# **PROPOSED CHLOR-ALKALI PLANT CSBP & FARMERS PTY. LTD.**

**Report and Recommendations  
by the  
Environmental Protection Authority**

Bulletin 216 September 1985

Figure 2 — Comparison of Chlorine Toxic Dose Data

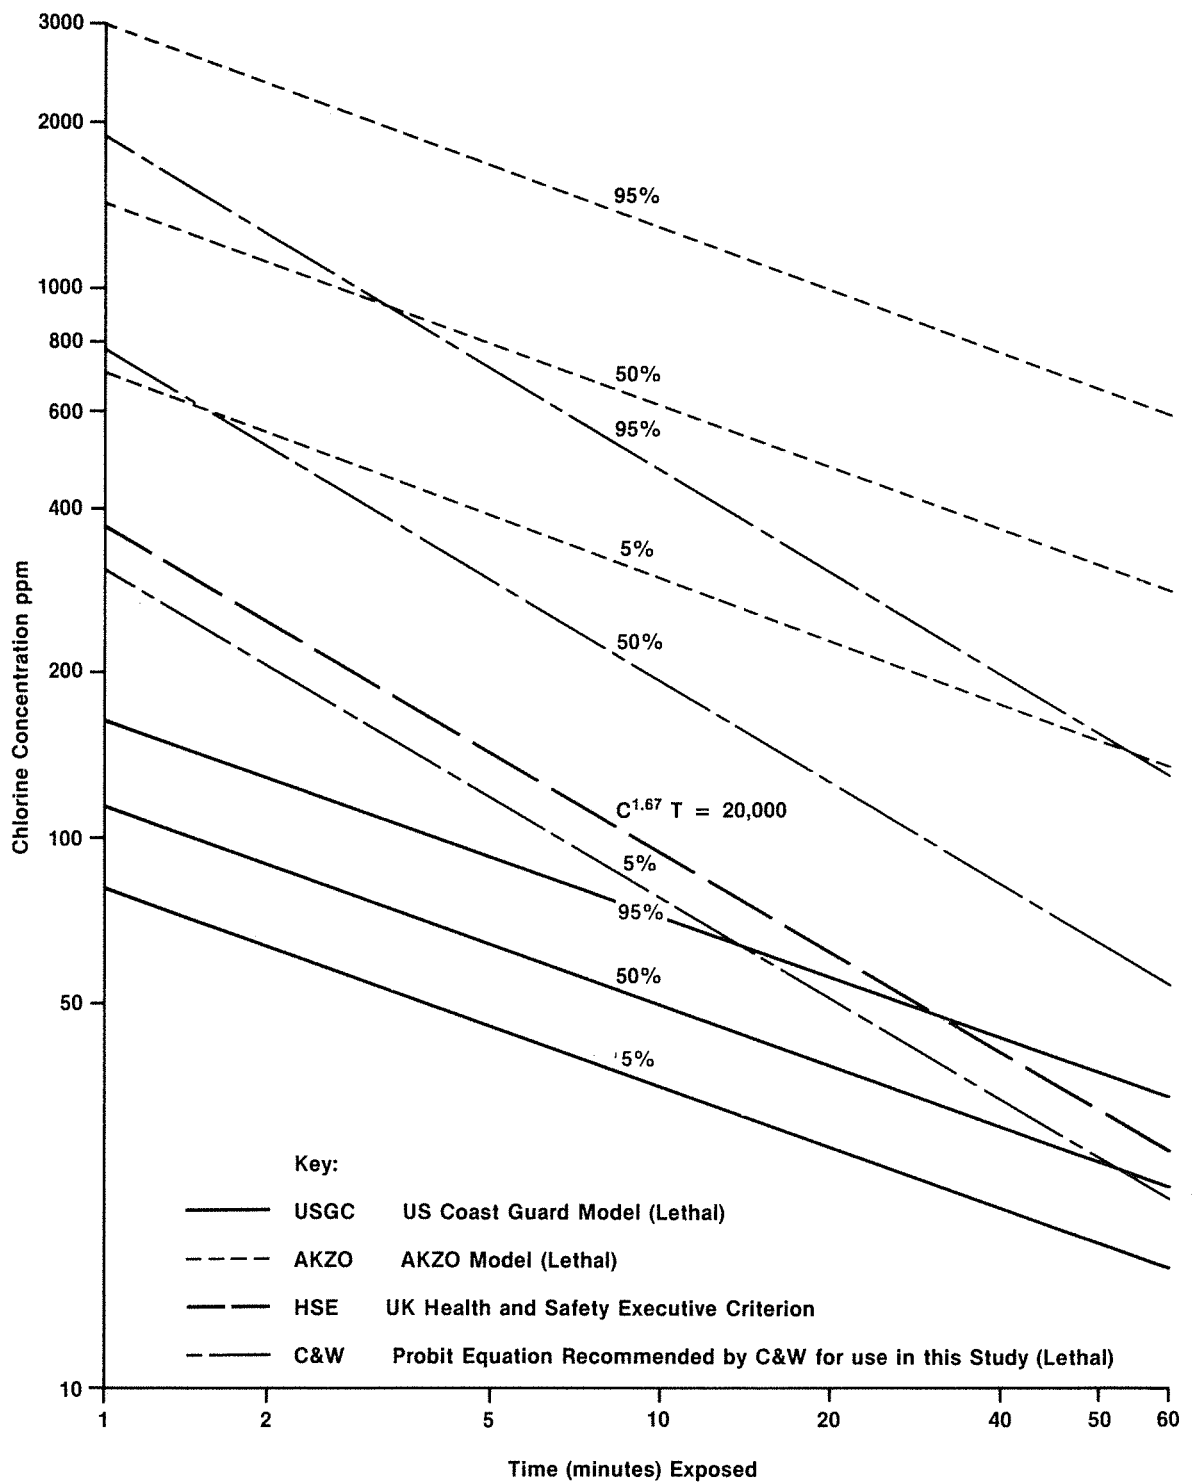
In order to carry out their risk assessment, CWL adopted chlorine toxicity doses that are illustrated in Figure 2.

A comparison of Table 5 and Figure 2 indicates that potentially lethal levels of gaseous chlorine would be experienced at some distance from the plant, in the case of a major event or failure.

Figure 3 — Indoor and Outdoor Levels of Risk

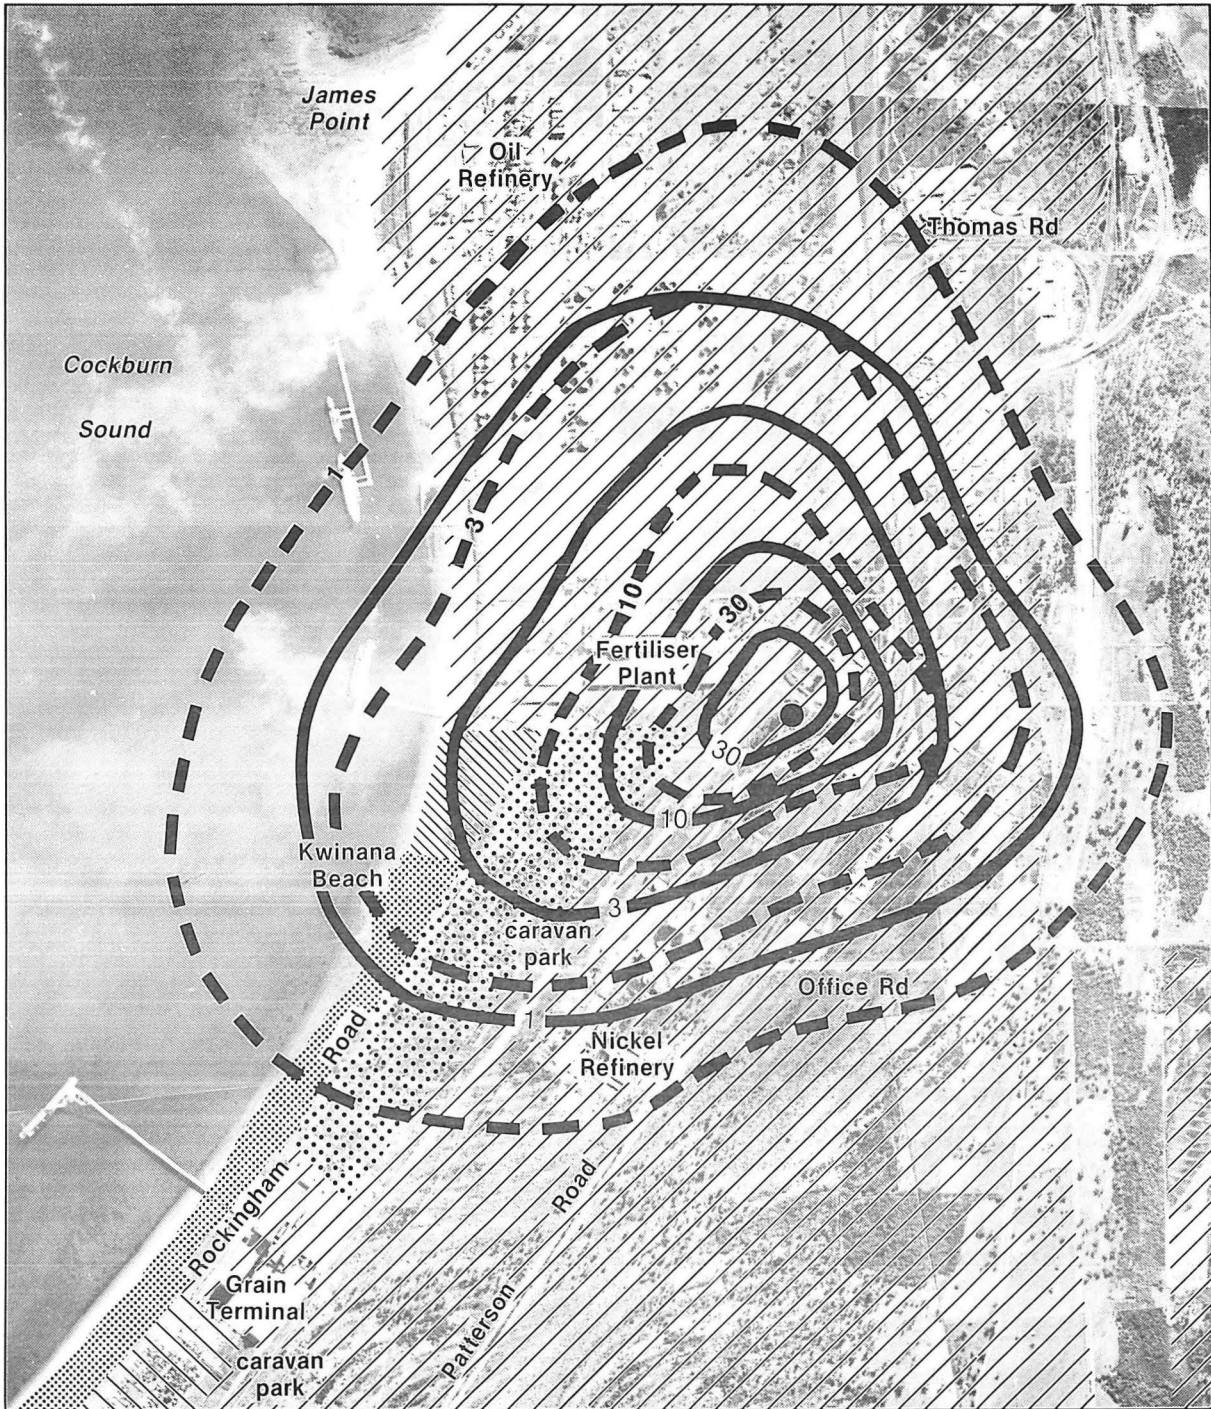
These levels are illustrated in Figure 3. The variation between indoor and outdoor levels of risk is due to restricted ventilation rates within buildings. Indoor concentrations of chlorine may be substantially lower than the outdoor concentration for short duration releases (CWL, p 5-3).

The Authority has adopted an individual risk standard of up to 50 in a million per annum within industrial zoned areas. Figure 3 indicates that the proposed chlor-alkali plant would be below that risk level and therefore the proposed site would be acceptable, in view of the industrial zoning of the area. However, residential land use at Kwinana Beach lies within an area that would be subject to individual risks that would exceed 1 in 1 million per year.

*The EPA recommends that the risk level associated with the proposed chlor-alkali plant would be acceptable given the industrial land use zoning of the area.*
